TRANSMITTAL LETTER

Publication 72M
 June 2010 Edition Change #4

**Revisions to
Standards for Roadway Construction
June 2010 Edition, Change No. 4**

SHT 3 OF 18
RC-50M

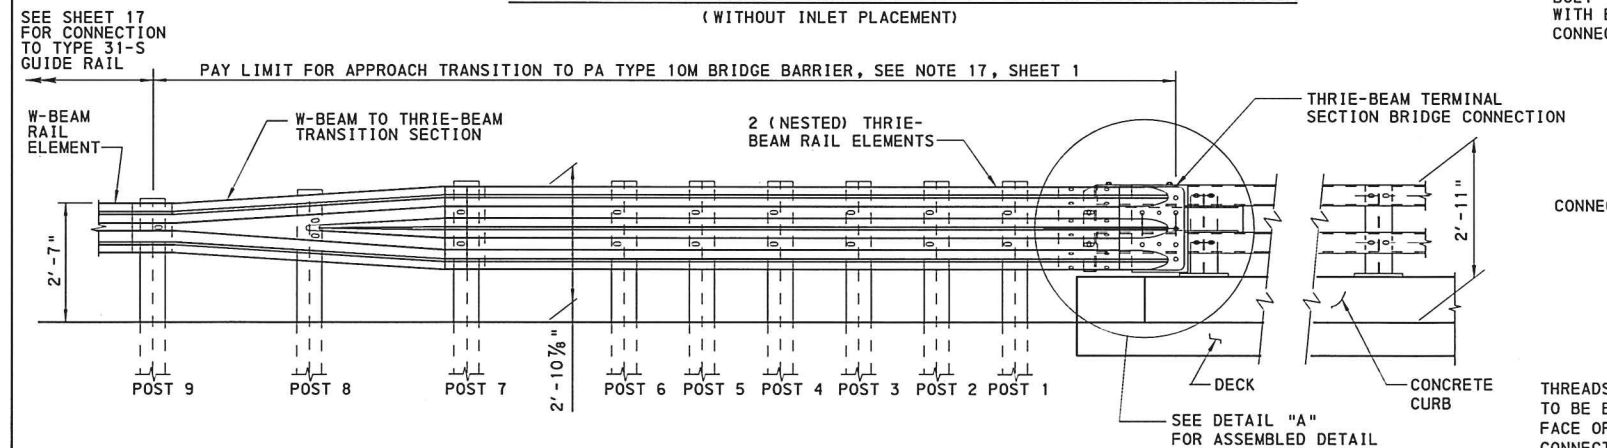
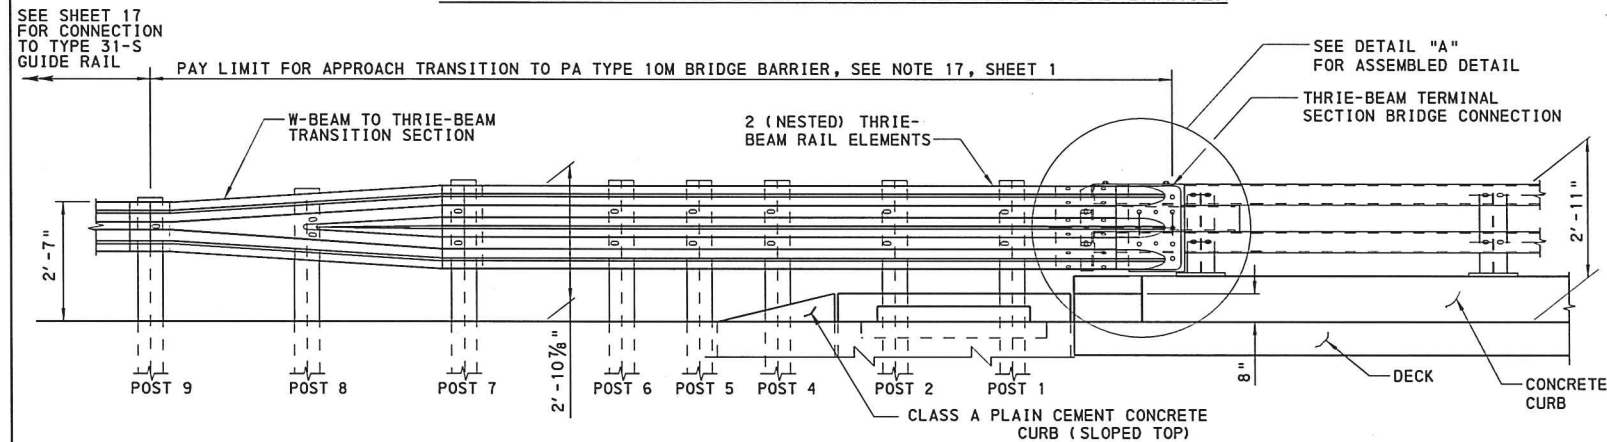
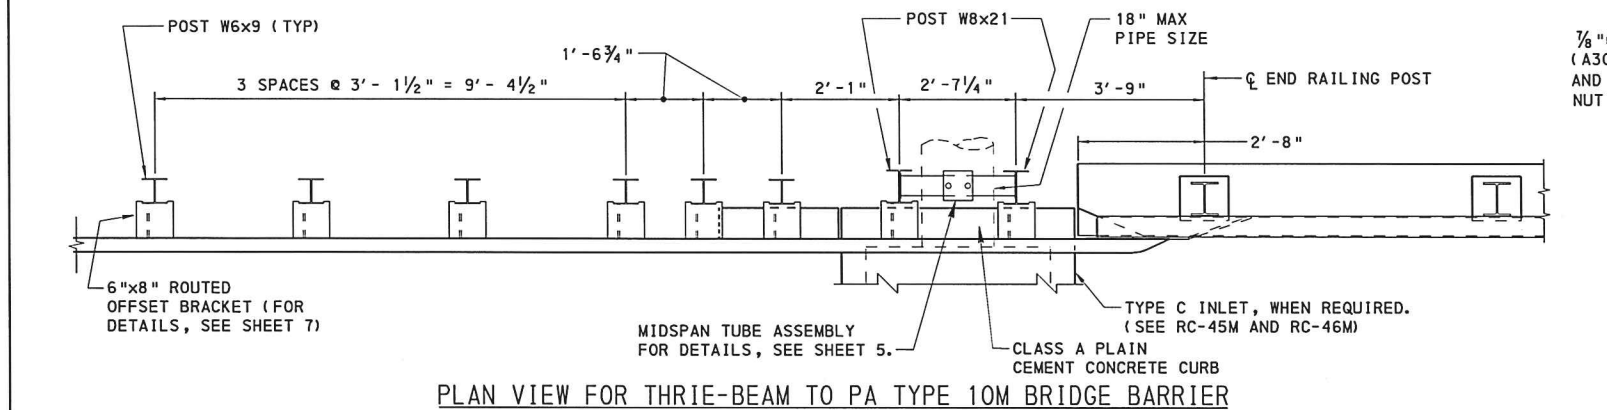
| | Sheet 3 | Revised W6 x 8.5 or 9 Post Details by increasing diameter of holes through the posts from 3/4" to 13/16" and adding reference to Note 4. Added Note 4 to state that a 3/4" diameter hole is permissible through the posts. |

SHT 7 OF 18
RC-50M

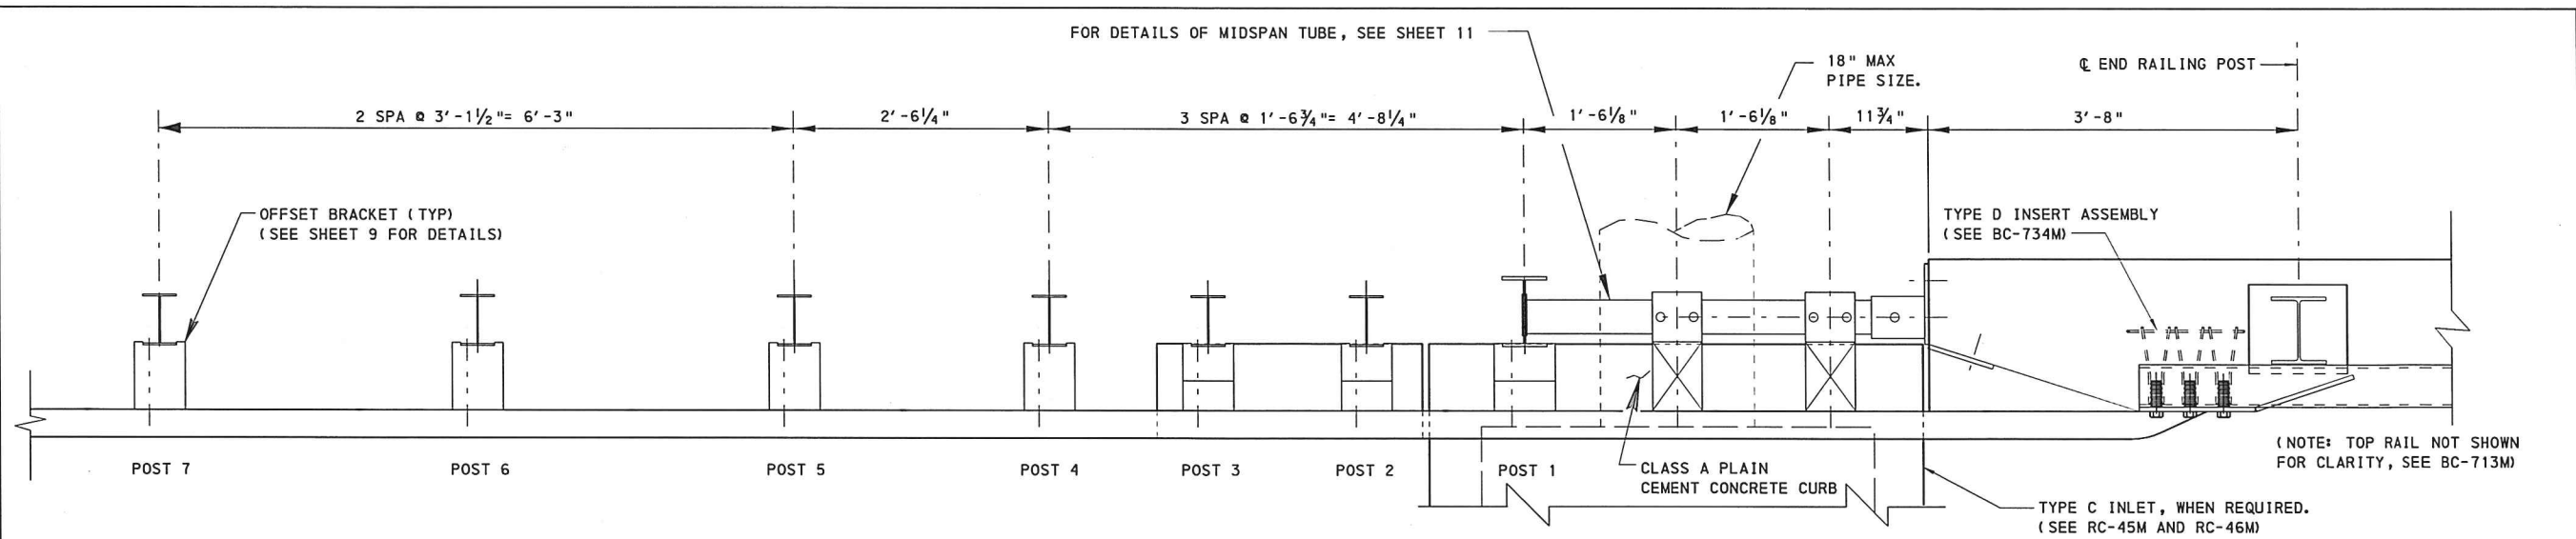
| | Sheet 7 Sheet 9 Sheet 14 | Revised Post Details by increasing diameter of holes through the posts from 3/4" to 13/16" and adding reference to Note 3. Added Note 3 to state that a 3/4" diameter hole is permissible through the posts. |

GRADING DETAILS

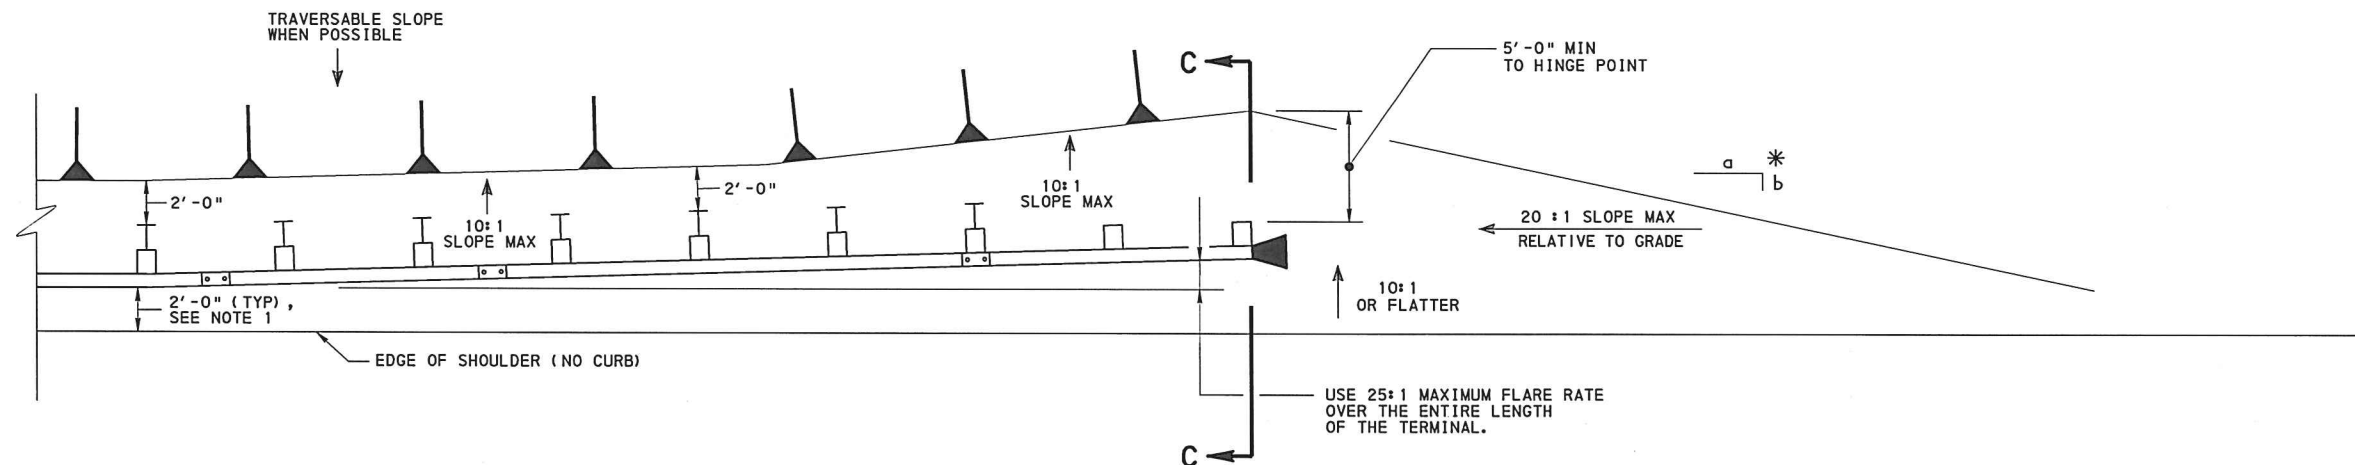
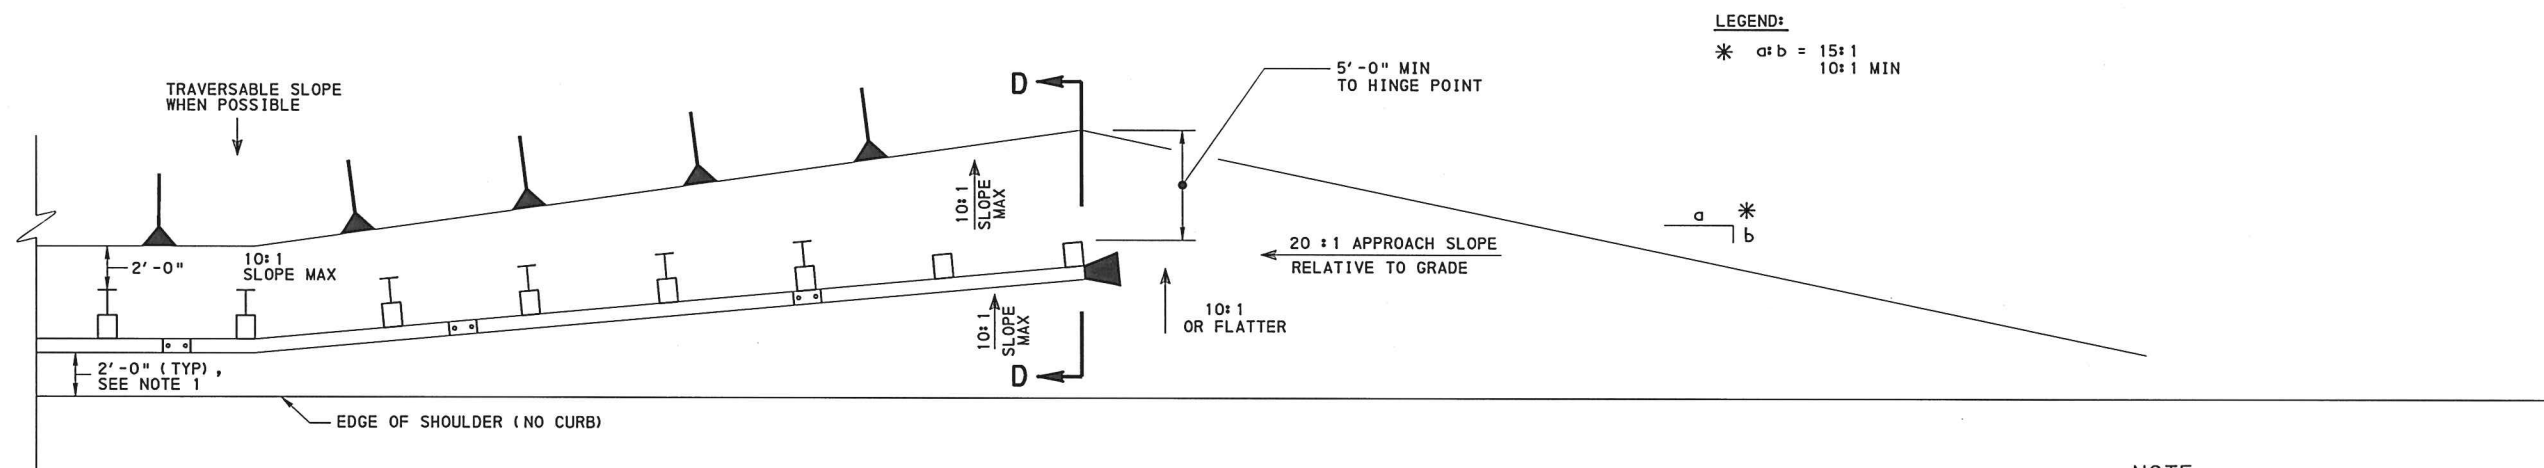
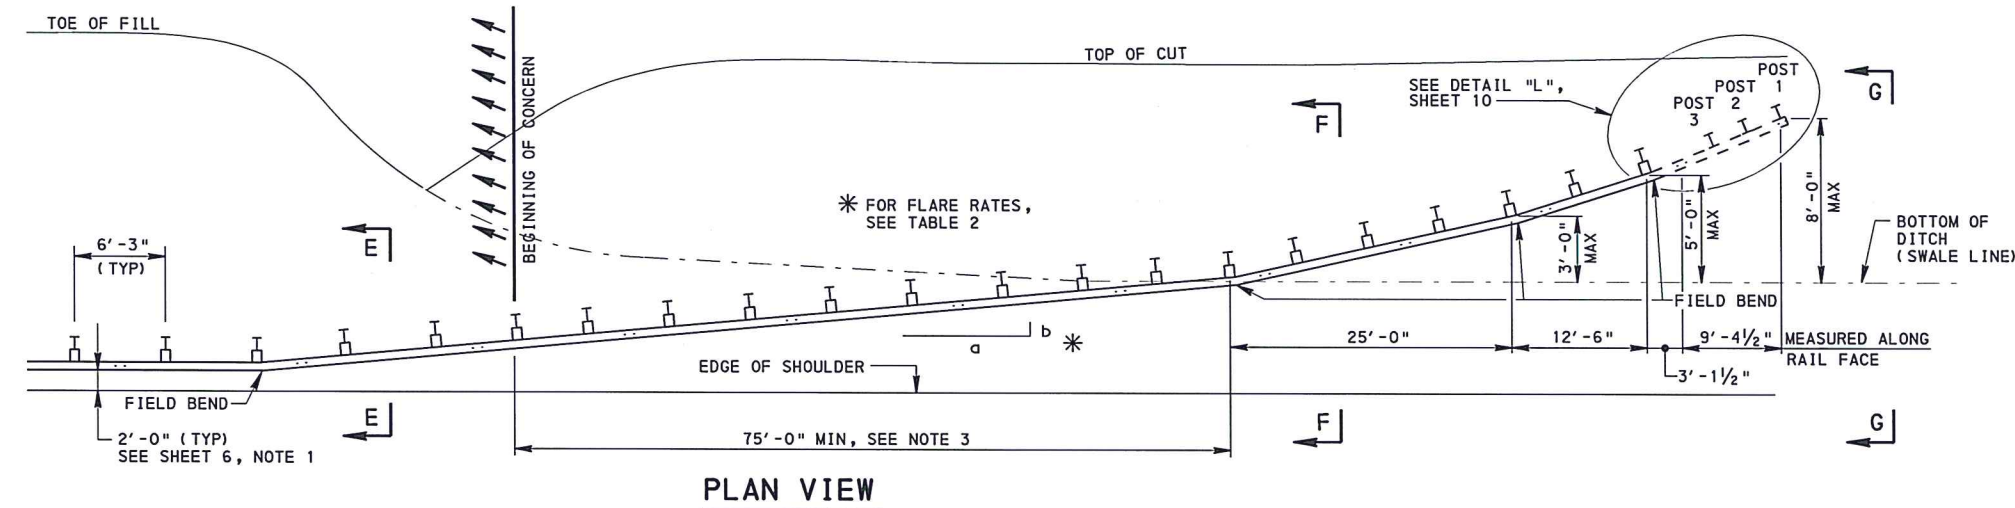
Revised Grading Detail for Tangent Terminals and Grading Detail for Flared Terminals details as follows:

Revised Grading Detail for Tangent Terminals detail as follows:

- Revised dimensions over the entire length of the tangent terminal from "1'-0" TO 2'-0" STRAIGHT TAPER OFFSET" to "25:1 MAXIMUM FLARE RATE".

BURIED-IN-BACKSLOPE TERMINAL
SINGLE RAIL

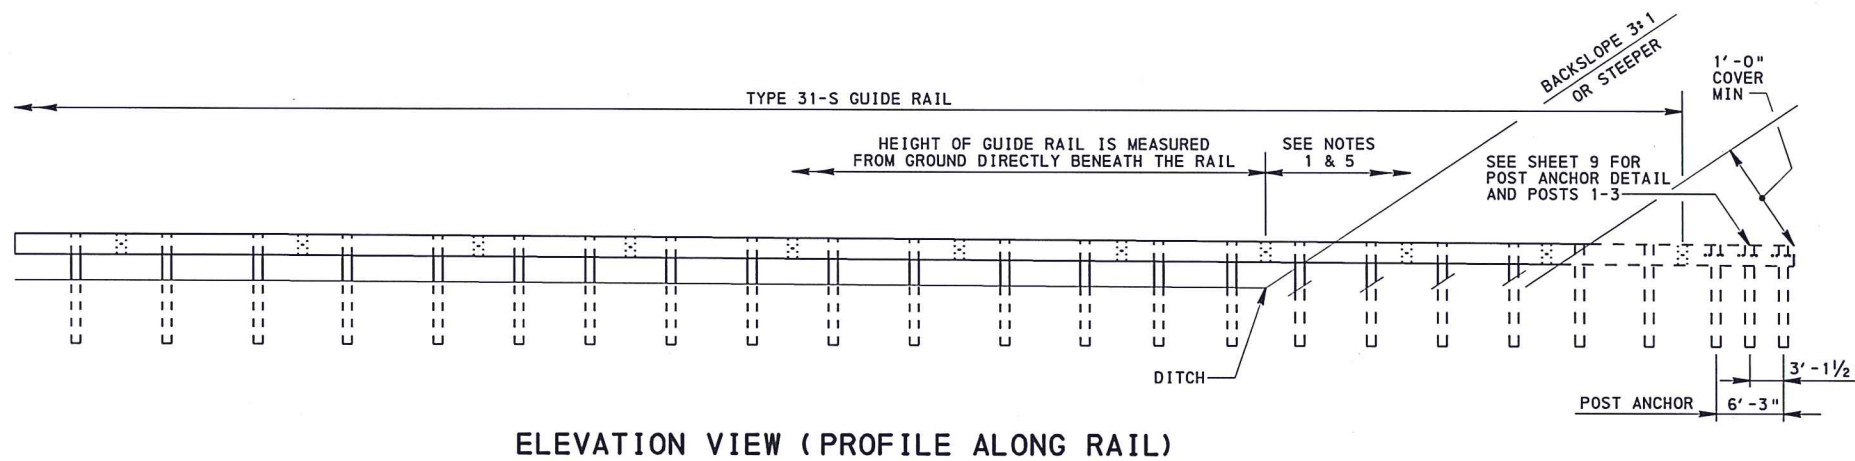
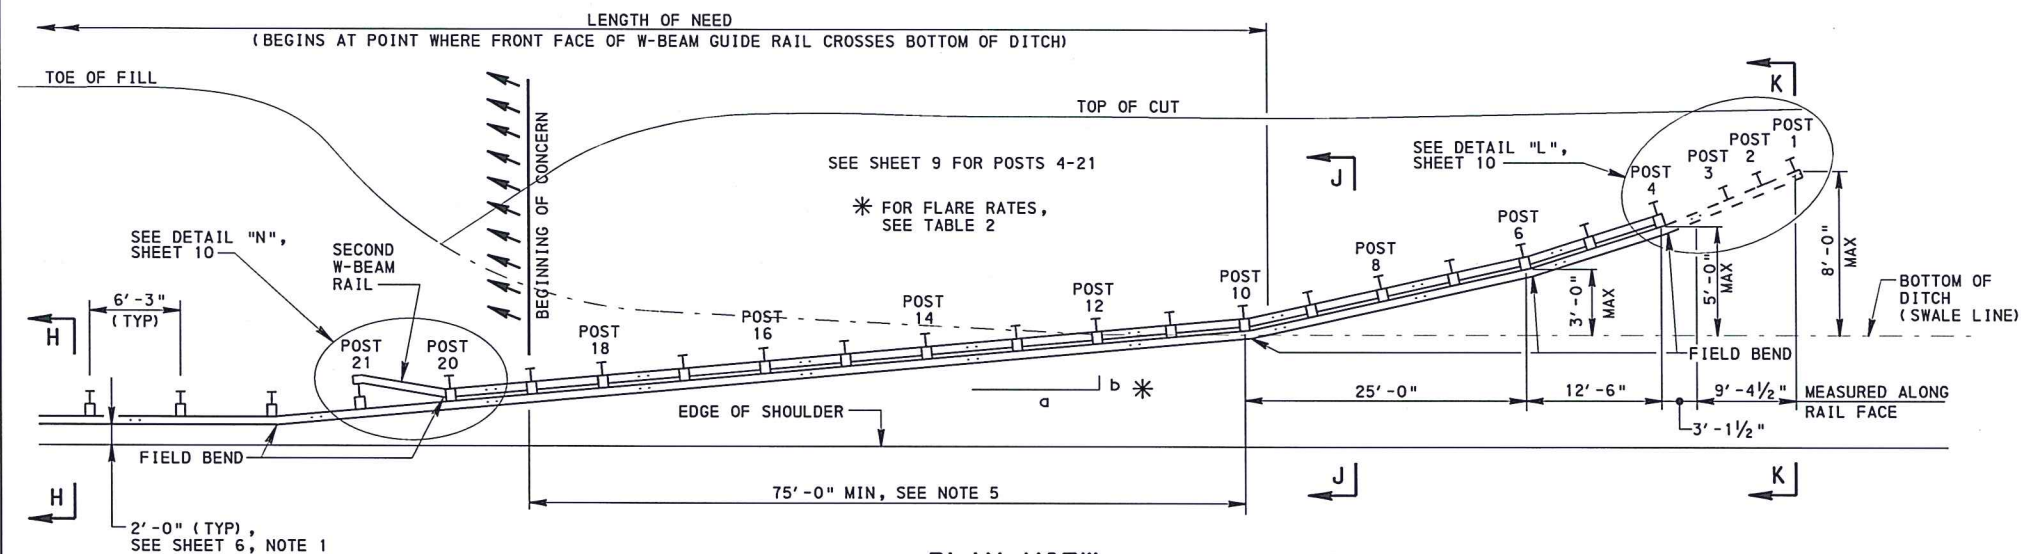
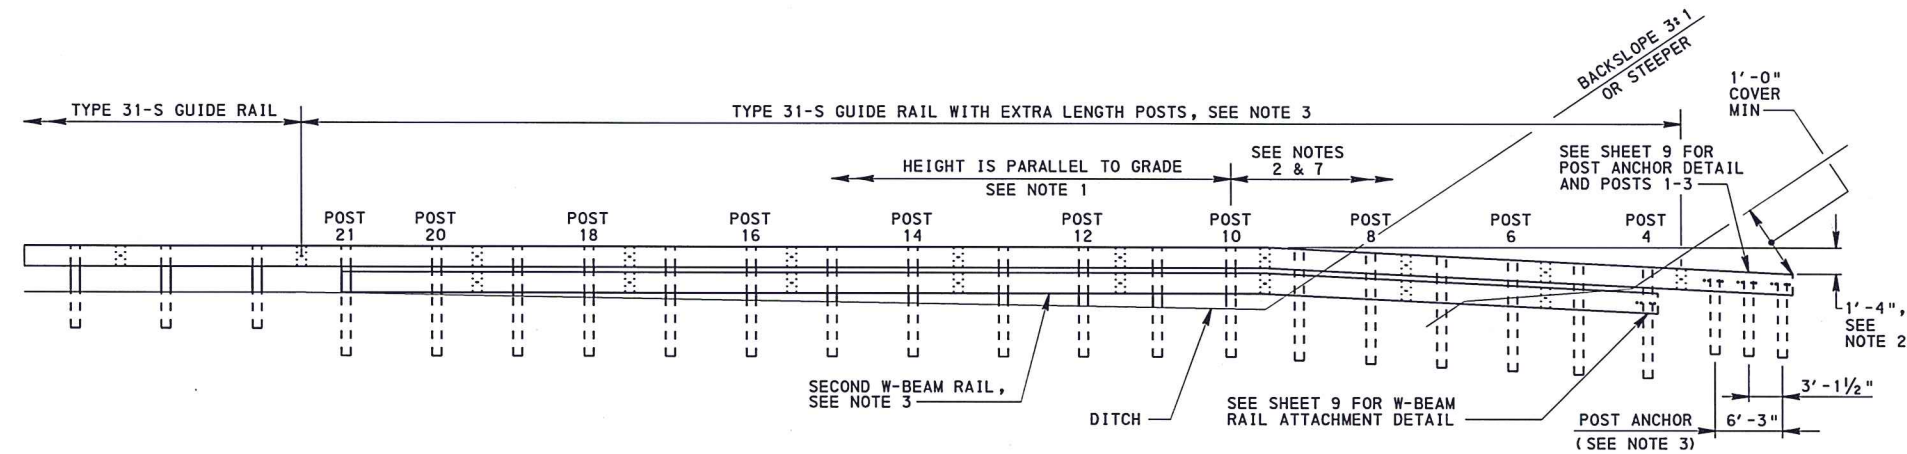
Revised Plan View detail for Buried-in-Backslope Terminal, Single Rail for consistency with the Buried-in-Backslope Terminal, Double Rail and as follows:

-Added symbology for mid-span splices.

-Added callouts for field bends of guide rail.

-Added labels for Posts 1, 2, and 3 that are buried in the backslope.

-Added callout to see Detail "L" on Sheet 10 that includes Posts 1, 2, and 3.

Revised Sections E-E, F-F, and G-G to add "OR FLATTER" after "10:1".

Revised Elevation View (Profile Along Rail) detail as follows:

W-BEAM RAIL ATTACHMENT (POST 4)

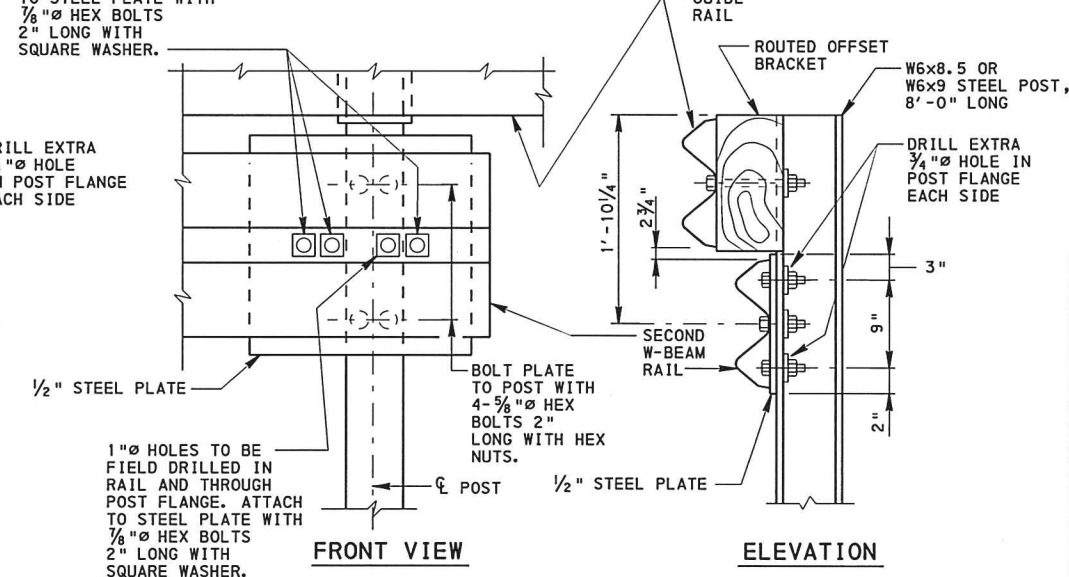
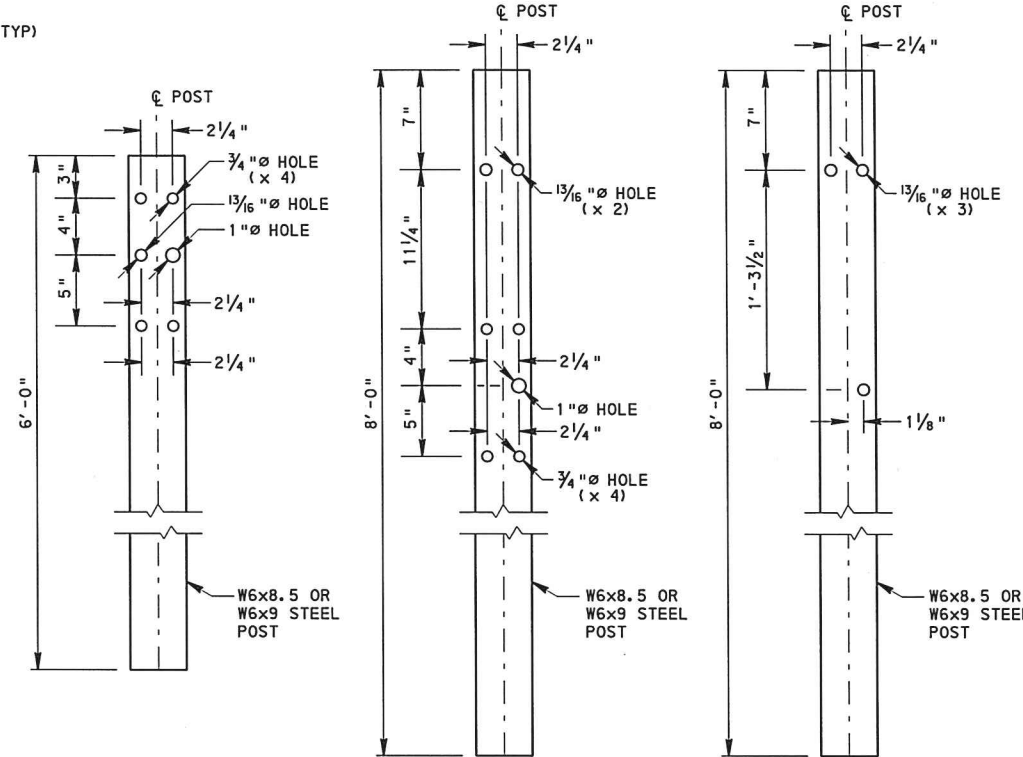
Added "(POSTS 1-3)" after "POST ANCHOR DETAIL".

Revised dimensions for Post Anchor Detail (Posts 1-3) as follows:

Added "(POST 4)" after "W-BEAM RAIL ATTACHMENT".

Revised dimensions for W-Beam Rail Attachment (Post 4) as follows:

- Changed width in Partial Plan from 8" to 7 7/8" left of the post centerline.

- Changed width in Partial Plan from 6" to 6 1/8" right of the post centerline.
